Murray-Mulholland-Liberty-Washington Residents Association

Subject: Treehouse Condominiums

Date: June 30, 1994

Treehouse Condominiums: Overview

**PROPOSED
 "RETENTION
 FACILITY"**

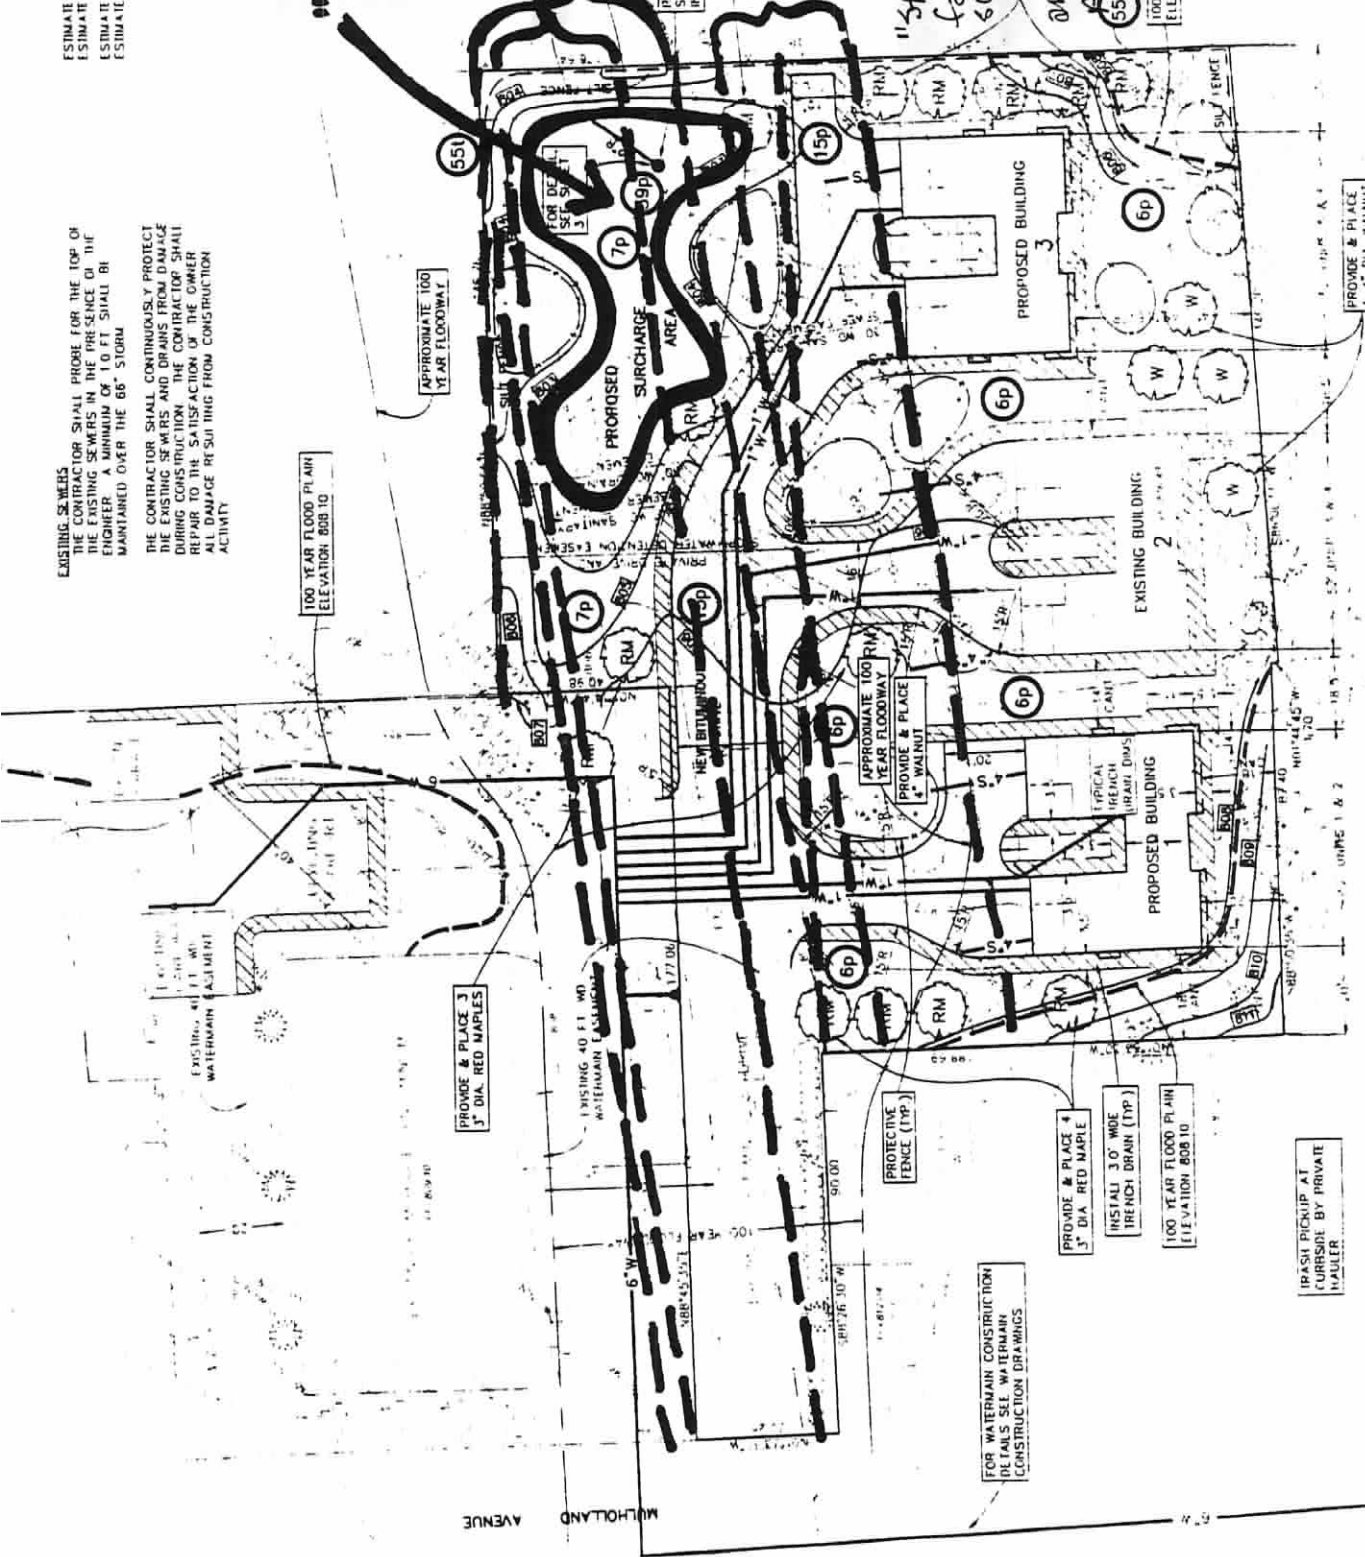
- subject to significant surcharging even during a one-year storm;
- approval to build a stormwater facility in the middle of a major public utilities easement, in direct conflict with City specifications;
 - one foot and 2.5 feet of coverage at storm and sanitary lines, respectively, where the City specifications are 3.5 and 5 feet;
 - approval to build modern buildings in the historic district; and
 - approval to build in the middle of the block, with living rooms looking down upon back yards only 20 feet away and headlights shining into windows.

The stormwater management system proposed for the site is based on the theoretical assumptions of the Rational Method---that because of times of concentration, the additional stormwater generated by impervious surfaces associated with the Treehouse Condominium development will be off the site and into the drain before stormwater from the upstream watershed reaches this location. Unfortunately, in the real world, storms often fail to follow the theoretical ideal, and do not fall uniformly over the watershed. Should a downpour sweep in from the west (as so often is the case), its peak of intensity over the Murray-Mulholland area could easily coincide with the arrival of peak stormwater flows from the upstream watershed, creating significantly higher flood elevations on site, and generating potentially serious off site impacts as well. On a site such as this, where known problems exist prior to development, an overly cautious design with significant room for error should be required. Instead, what is proposed is a system that could fail to function as portrayed in any but ideal circumstances.

We cannot endorse construction of the proposed condominium development on this site. Further, the stormwater management system does not meet the adopted rules of the Washtenaw County Drain Commissioner, and would not receive our approval were this office the agency of jurisdiction. We respectfully advise review and reconsideration by the City of its blanket exemption of sites under 15,000 square feet of impervious surface from on-site stormwater management requirements. Exemptions should be granted on a case-by-case basis, based on evaluations of site-specific circumstances.
